ADDENDUM No. 1: May 8, 2015

PROJECT: St. John the Baptist Parish
Volunteer Fire Station #51
LaPlace, Louisiana

PROJECT NO.: SA 21167.00

1 PARTIAL POWER AND IT - 2ND FLOOR
ESK004 1/8" = 1'-0"

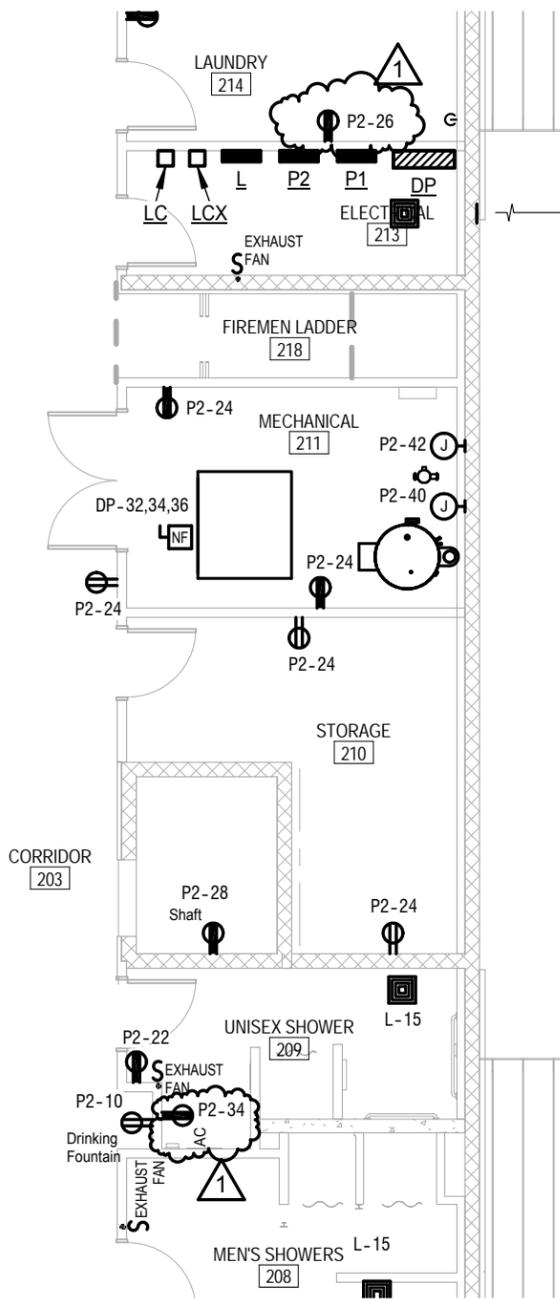
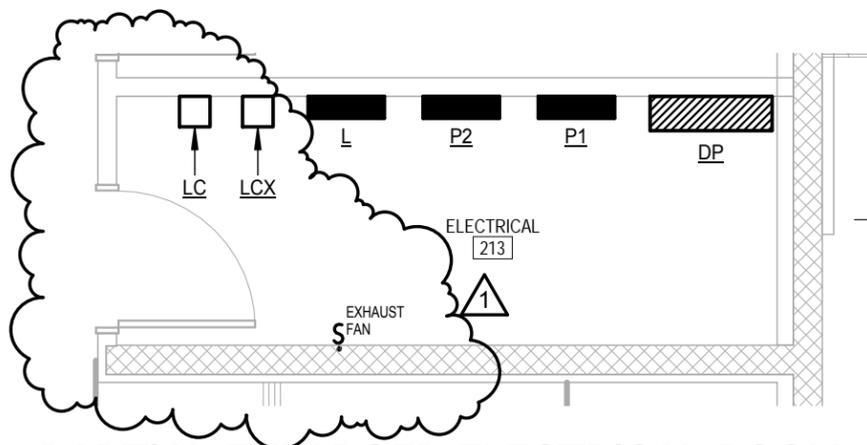
Revise Second Floor Power Plan as shown on attached sketch ESK004.

1 PARTIAL SS - 1ST FLOOR
ESK005 1/8" = 1'-0"

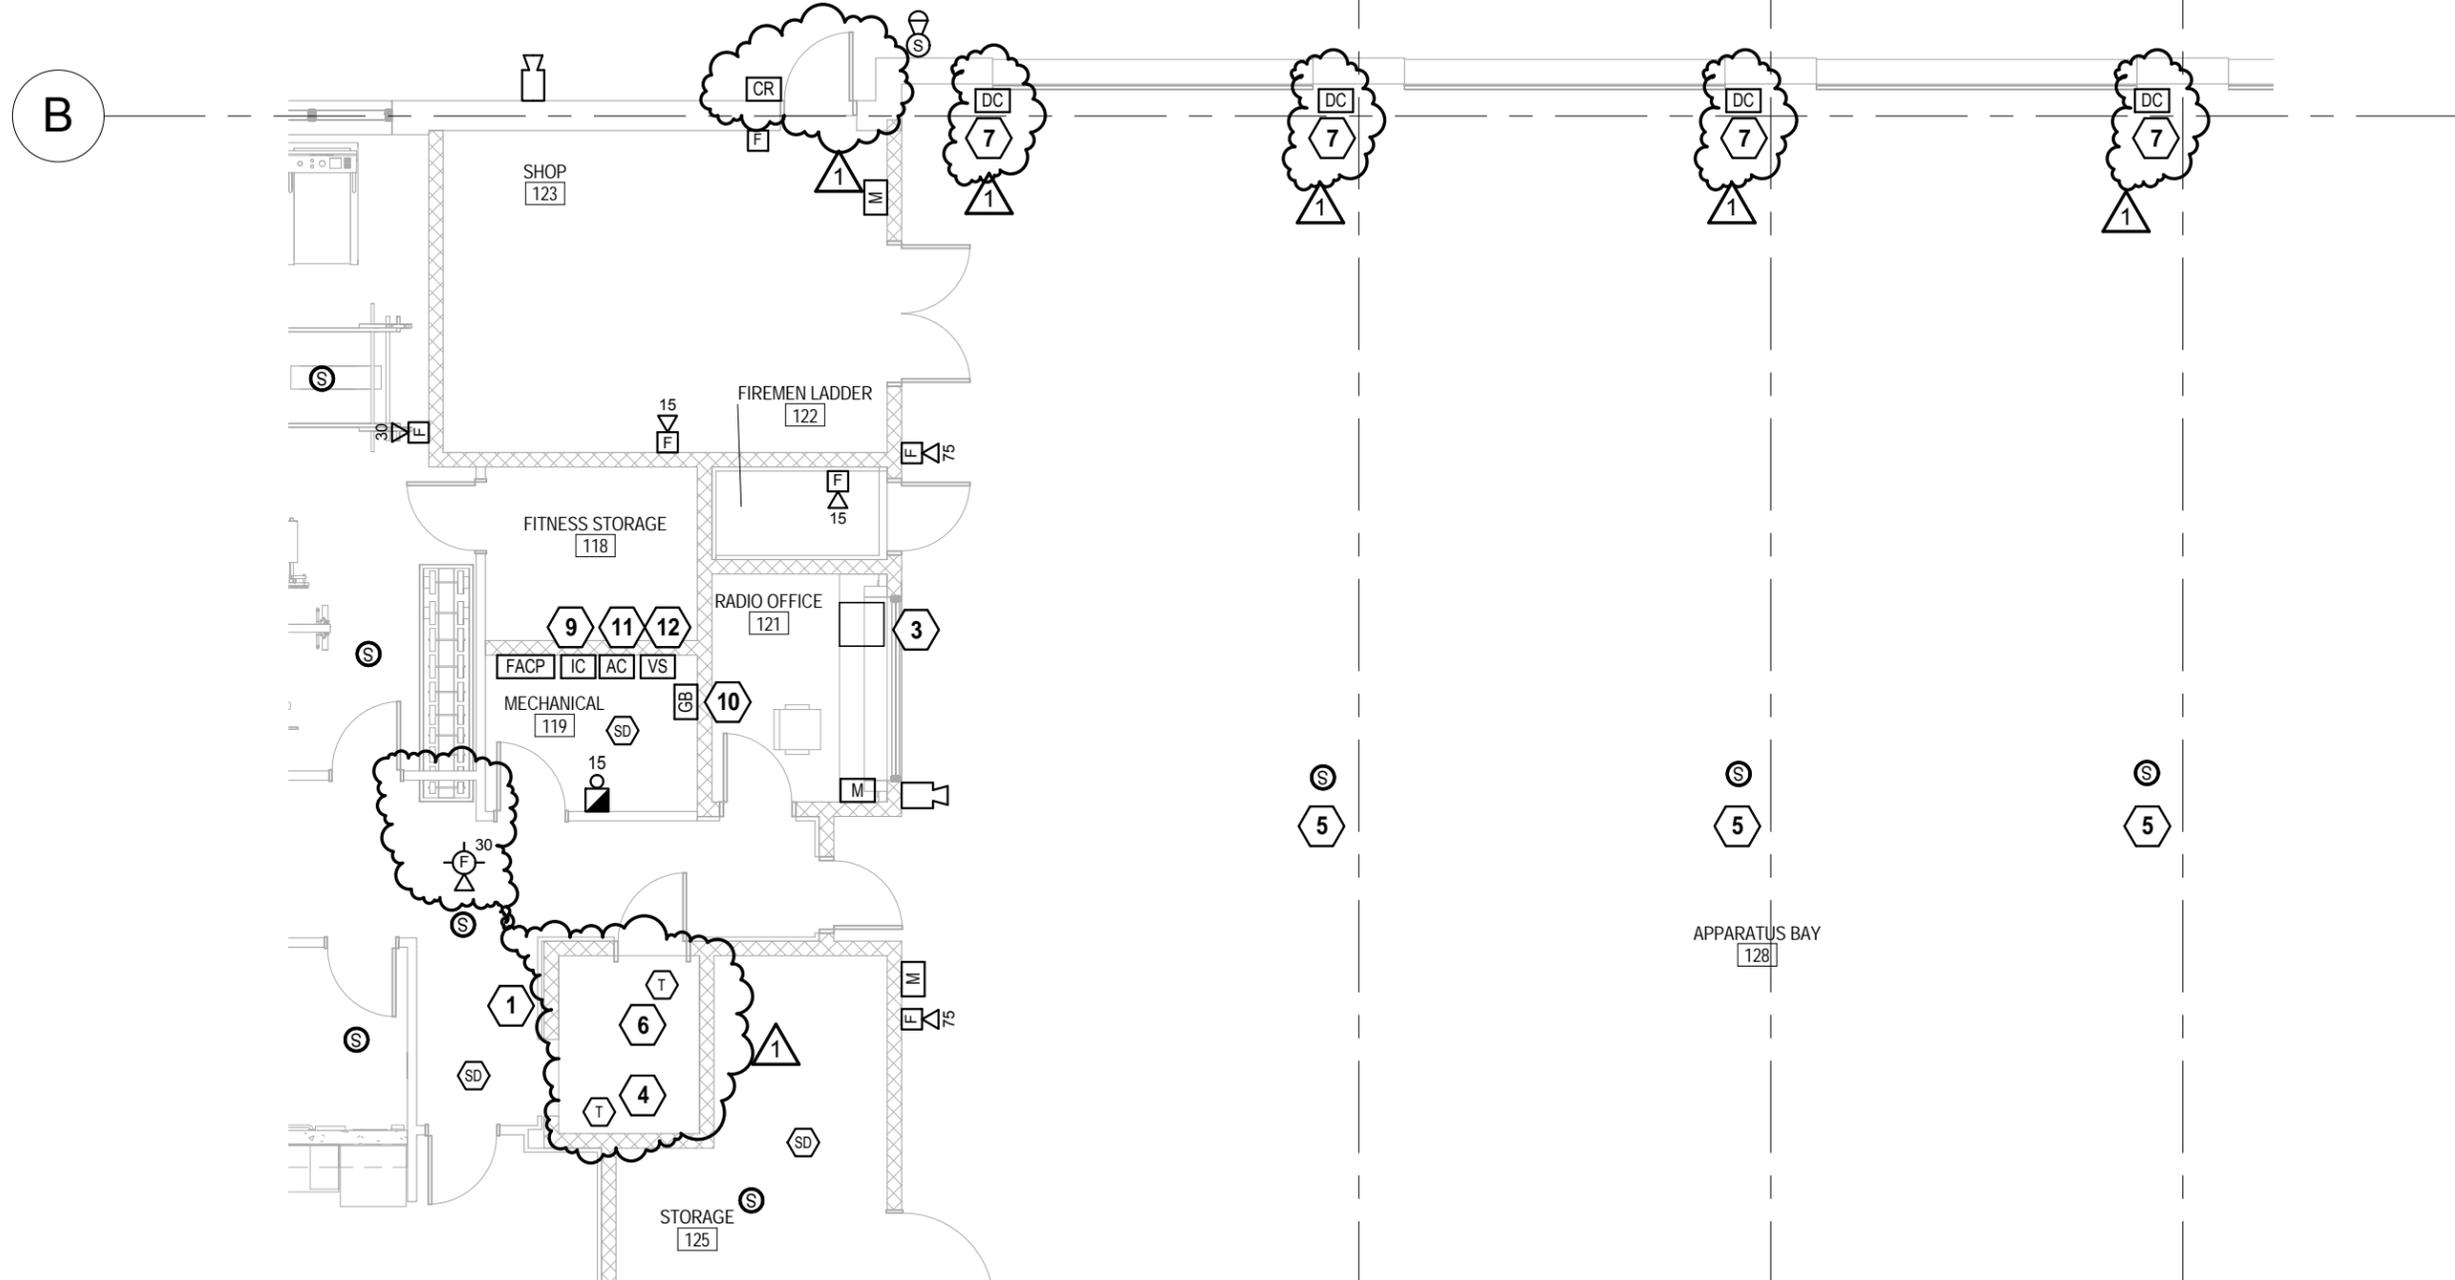
Revise Special Systems First Floor Plan as shown on attached sketch ESK005.

1 PARTIAL SS - 2ND FLOOR
ESK006 1/8" = 1'-0"

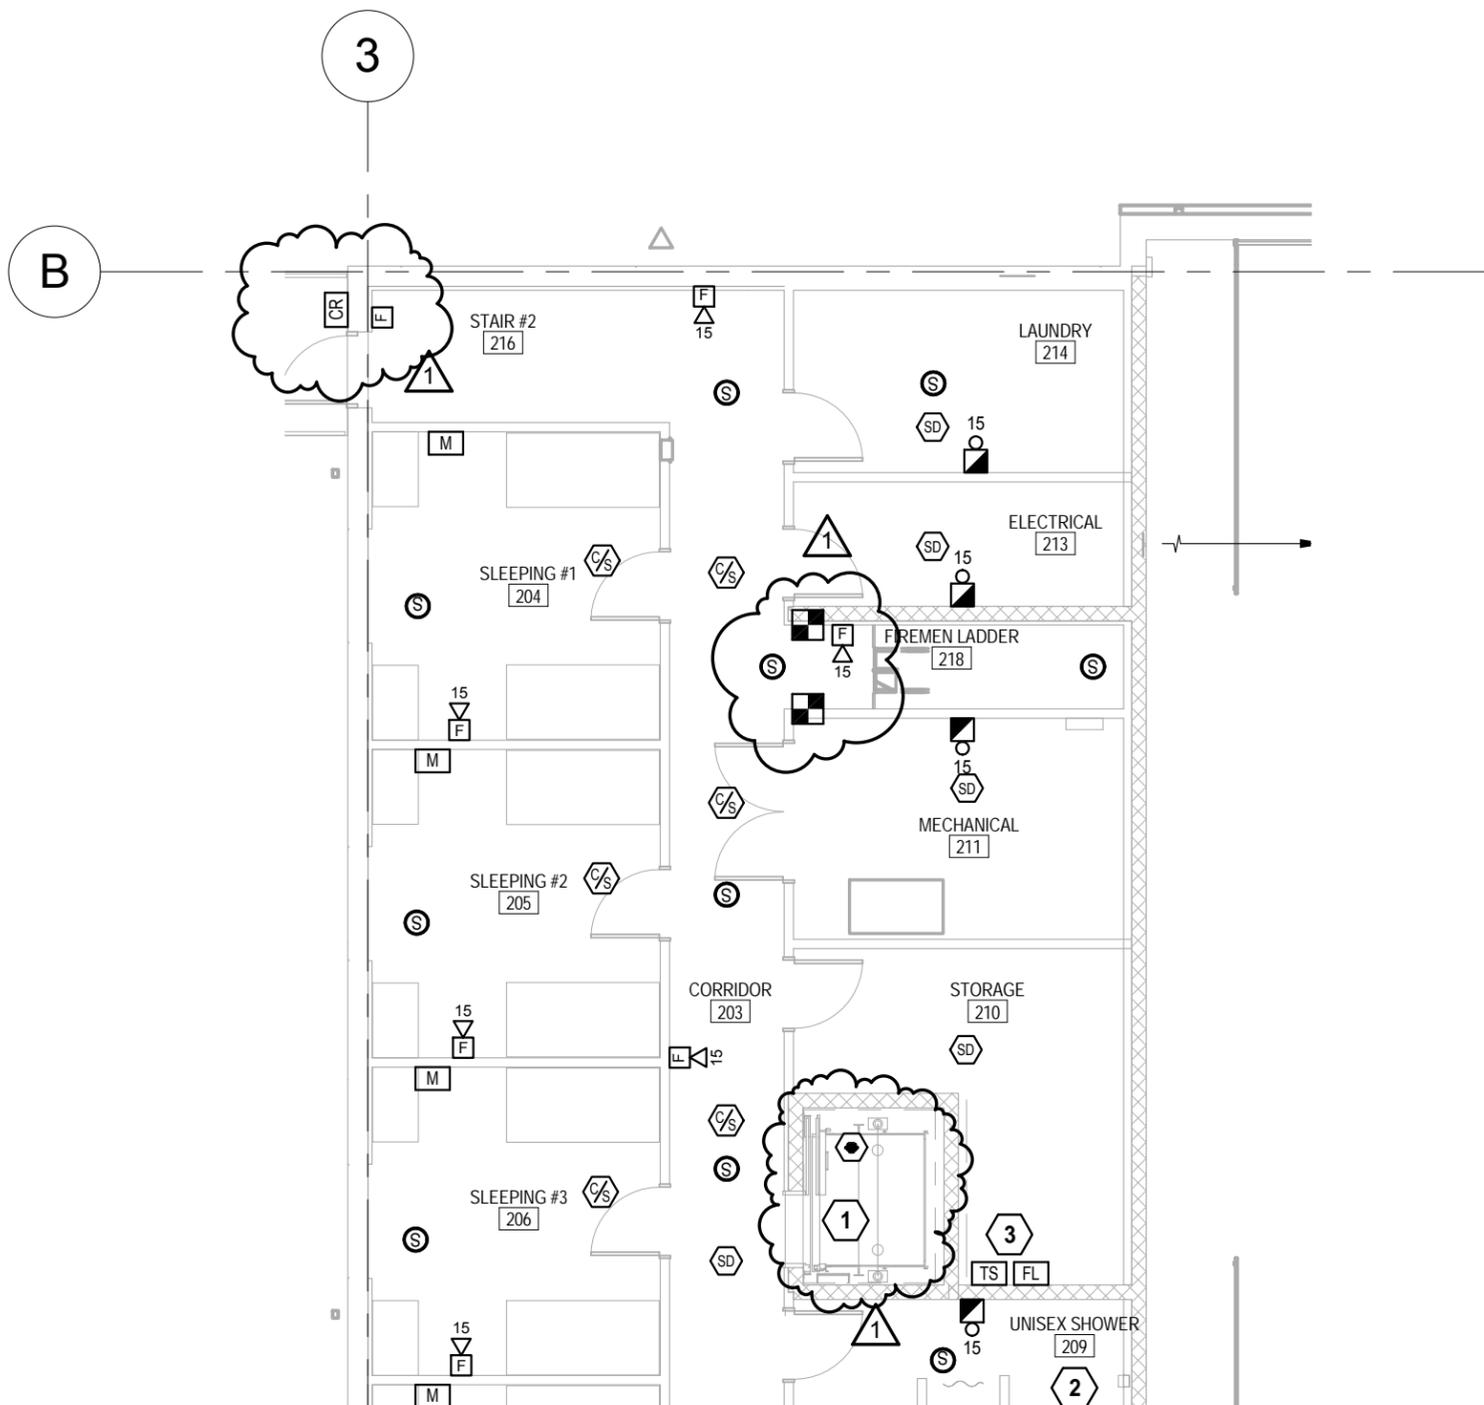
Revise Special Systems Second Floor Plan as shown on attached sketch ESK006.
